Addendum No. 1, September 20, 2024

Re: Agriculture Technology Innovation Center  
Tennessee Technological University  
Cookeville, TN

From: Upland Design Group, Inc.  
P.O. Box 1026 (38557)  
362 Industrial Blvd.  
Crossville, TN 38555  
Telephone (931) 484 7541  
Fax (931) 484 2351

**D1.1**

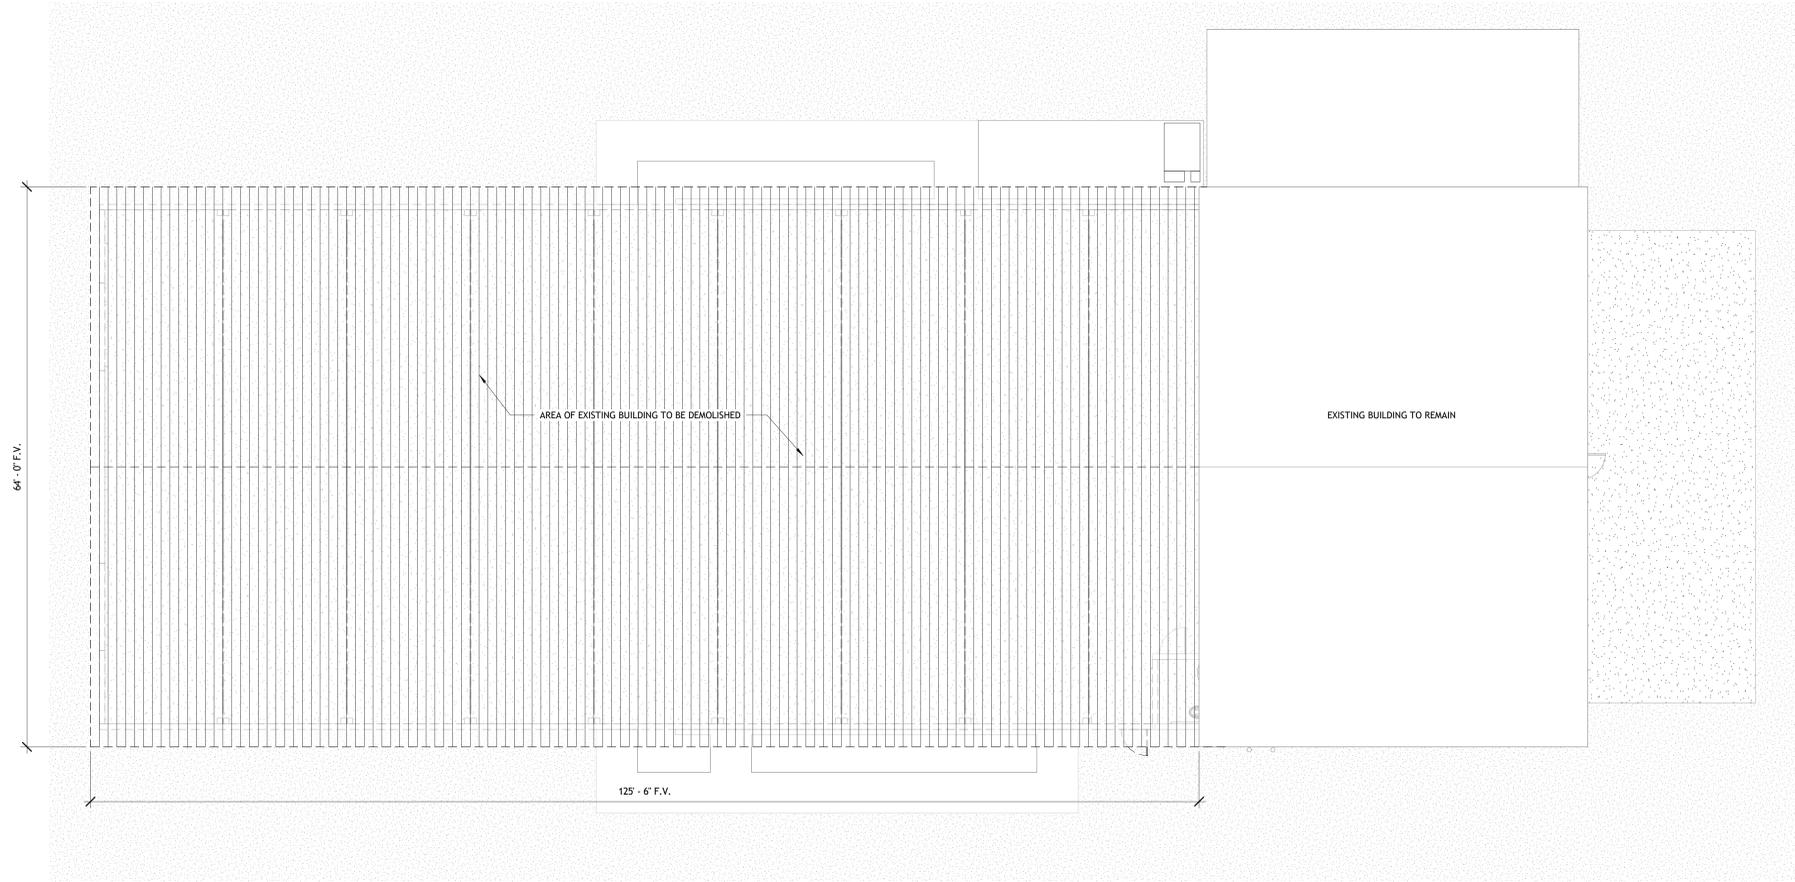
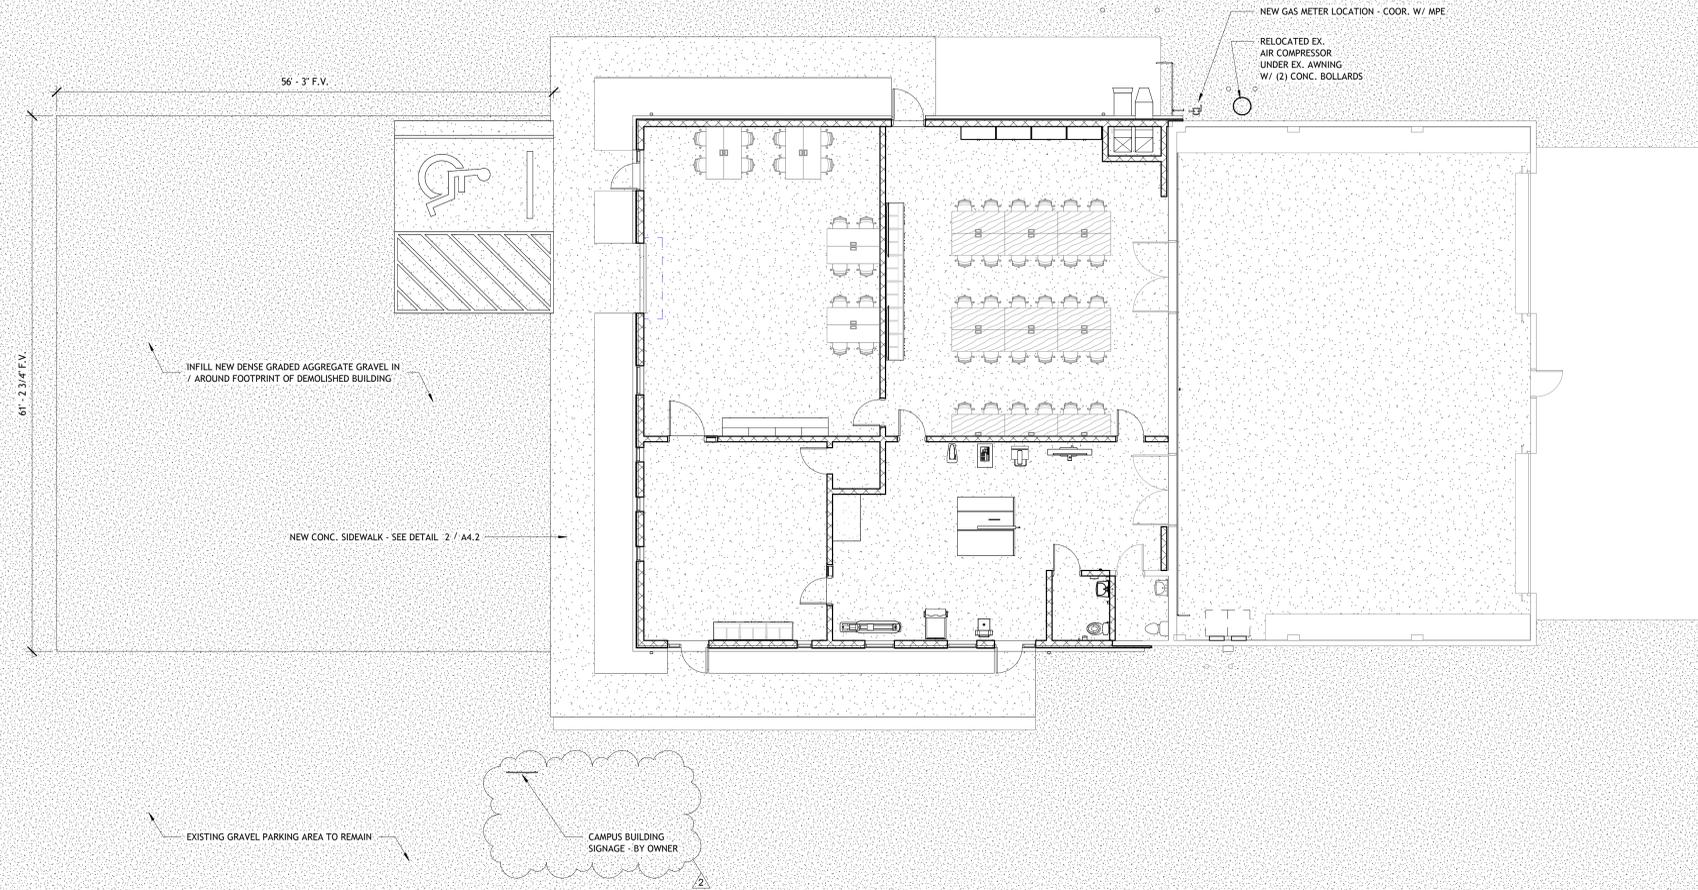
8. Refer to Architectural Drawings COVER, D1.1, A0.1 and A1.1, Replace with attached drawings COVER, D1.1, A0.1 and A1.1, Revised date 9/20/24. Interior signage types and locations added and existing sidewalk to be demolished and new sidewalk layout have been clarified.
9. Refer to Electrical Drawings E0.1 and E1.1. Replace with attached Drawings E0.1 and E1.1, Revised date 9/20/24.
10. Refer to attached Drawing HBAR-2 for clarification on new fiber cable routing and information.
